RE: 3190 Daisy Road
SGP-23-063

PERC TEST PLAT

RE: **Percolation Certification Plan**

3190 Daisy Road

#1 SOIL PROFILE

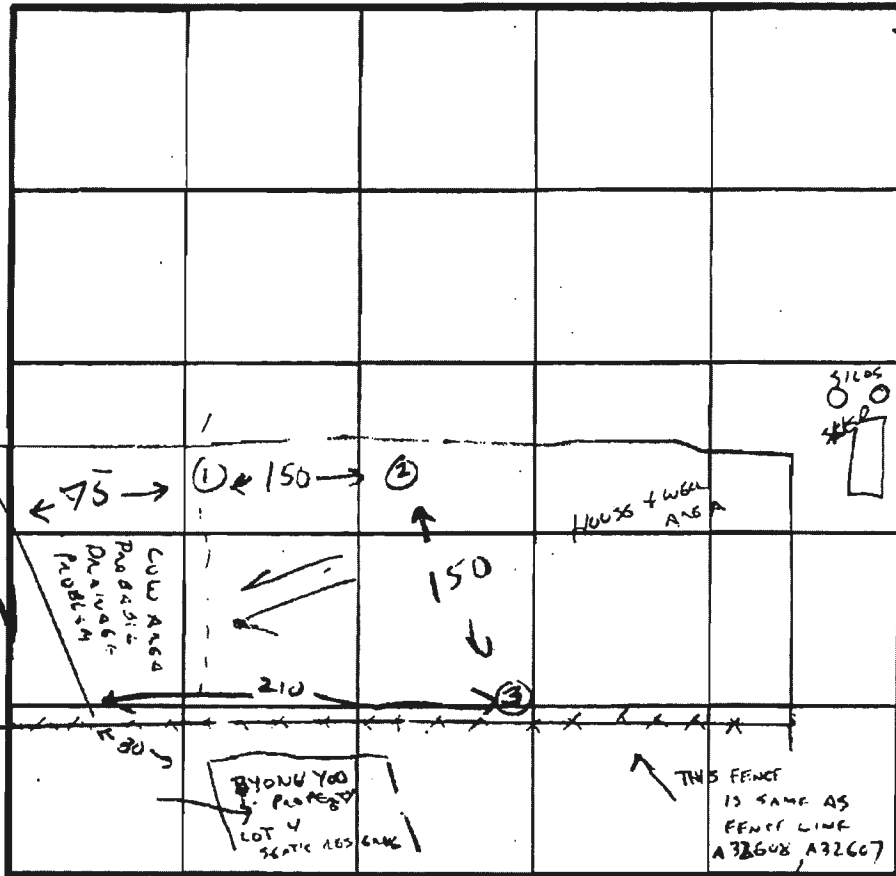
REMARKS SOILS OK, PLAT REQUIRED - SEE ALSO TEST NOTES A32608, 32607 OF 4/28/51

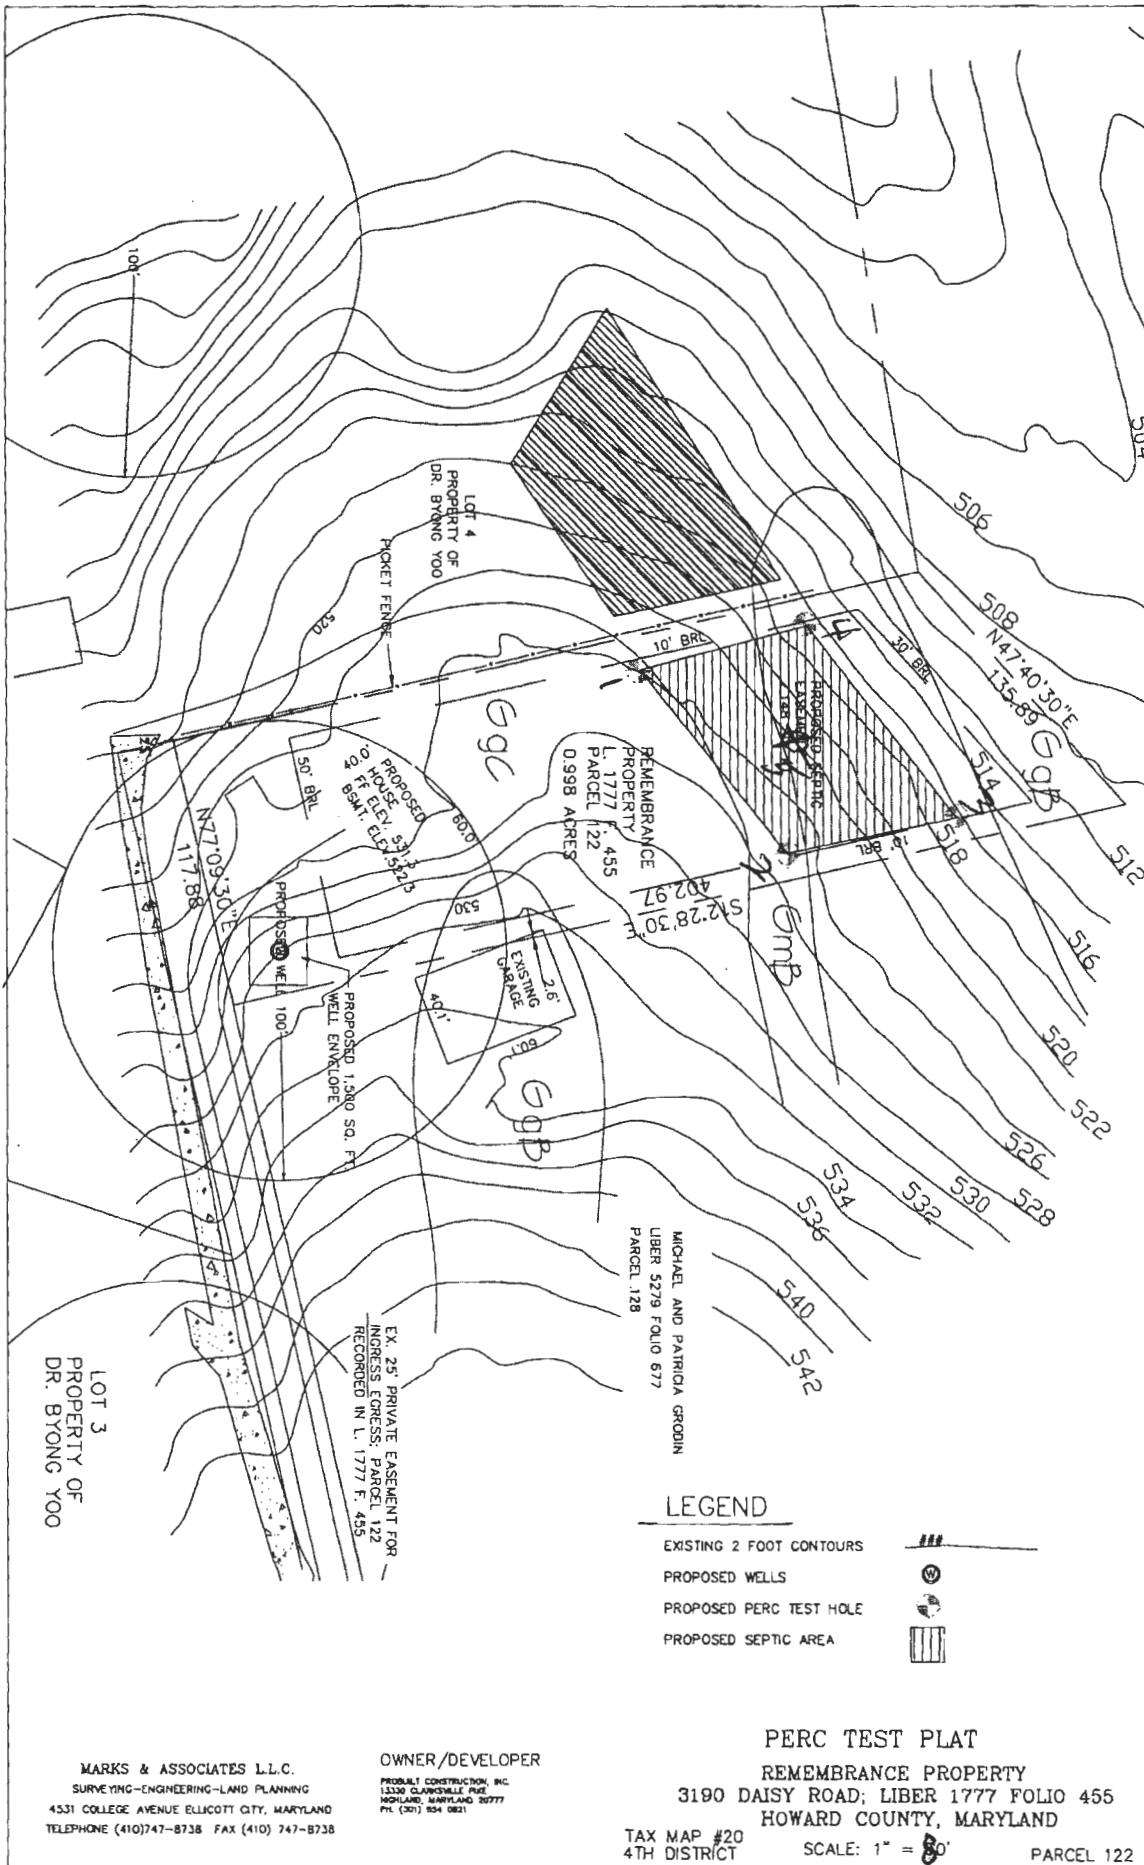
12. The well needs to be at least 50 feet from the stormwater inlet grate at the front of the driveway.

Well box moved to provide 50' from stormwater inlet grate at the front of the driveway.
